DEFENSE LOGISTICS AGENCY
DEFENSE NATIONAL STOCKPILE CENTER
8725 JOHN J. KINGMAN ROAD, SUITE 3229
FT. BELVOIR, VIRGINIA 22060-6223

Re: License STC-133
Docket: 040-00341

SUBJECT: Request For Additional Information Concerning Application For Amendment To
License, Control No. 136268

In reference to your letter of July 20, 2005, the Defense National Stockpile Center (DNSC)
submits the enclosed additional information concerning the Final Status Survey Report (FSSR)
for portions of the DNSC Scotia depot in Scotia, New York dated December 2004.

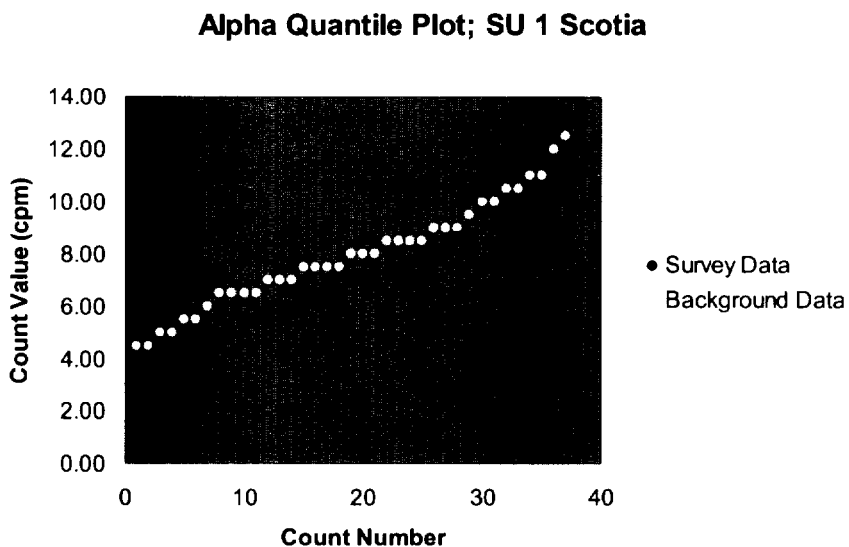
- 2.a.i. *Explain why it is reasonable to combine the results of the three sets of background measurements, considering that the area from which locations 1 through 30 were taken was significantly higher than the other two background areas.*

Outside Area 300 is a pad 390 feet by 270 feet in size surrounded by a chain link fence. Its pad consists of macadam with gravel which runs continuously under the fence to the road surfaces on the south and west sides. The area of concern for the radiological survey is an area of 70 feet by 90 feet located in the middle of the storage pad where the radioactive material was stored.

The background survey units were each taken on this pad. The first 30 measurements were taken on this pad just outside the fence on the western side. The second and third sets of 30 measurements were taken within the fence to the east of the actual survey unit. All background measurements were collected on the same continuous pad. There was no indication of different pours of material, different types of rock, or other differences that would account for the differences in background. Therefore the combination of all three background areas was considered reasonable as the large number of sample points would serve to minimize the standard deviation or the variation in the number.

The cause of the difference could be weather related. The background data were collected on August 13, 2003. Surveys began at 0700 with the western location (locations 1-30) and finished at 1230 at the southern location (locations 61-90). The weather for the previous day and during the day the survey was performed was cloudy with thunder storms nearby. It is possible that the data collected from the western area was affected by radon buildup which had dissipated by the time the other areas were surveyed.

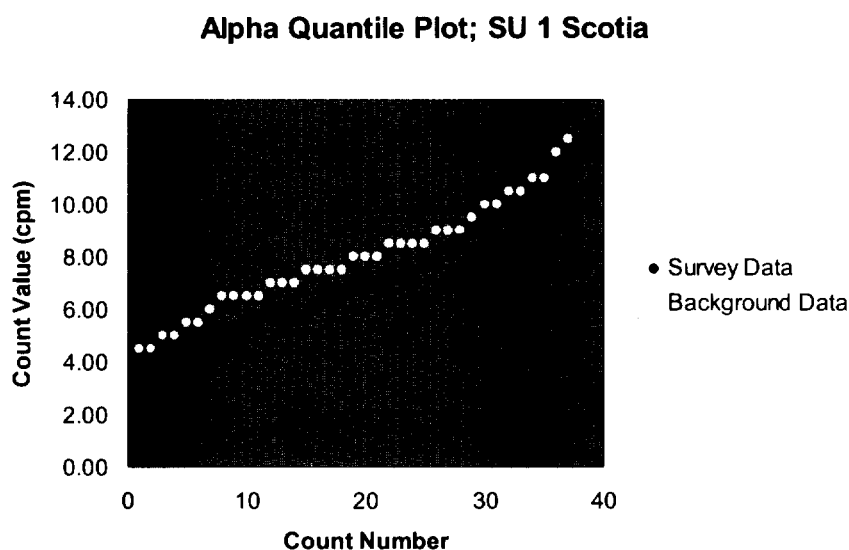
2.a.iii. *Explain why Survey Unit 1 measurements were significantly lower than the measurements made in areas which were considered to be unaffected (background areas).*

While there is a difference between the averages, we do not agree with that difference as being characterized as significant. As stated in the response above, the pad where the background and survey unit measurements were taken is one continuous pad and therefore made of the same

constituents. This, according to MARSSIM, is ideal for obtaining background measurements. On the surface there is no obvious reason for the differences in the data groups.

The cause of the difference could be weather related. The background data were collected on August 13, 2003. Surveys began at 0700 with the western location (locations 1-30) and finished at 1230 at the southern location (locations 61-90). The weather for the previous day and during the day the survey was performed was cloudy with thunder storms nearby. It is possible that the data collected the background was affected by radon buildup.

The range of the data points from the 2 background survey locations was 4.5 – 12.5 cpm. The range of data points from the survey unit was 1.3 – 10.3 cpm. These two ranges overlap well and do not show a significant difference. Below is a quantile plot of the two data sets. Note that the slope of each line is similar and that the two data sets intersect. This indicates that the two data sets are similar and that there is not residual radioactivity in the survey unit.
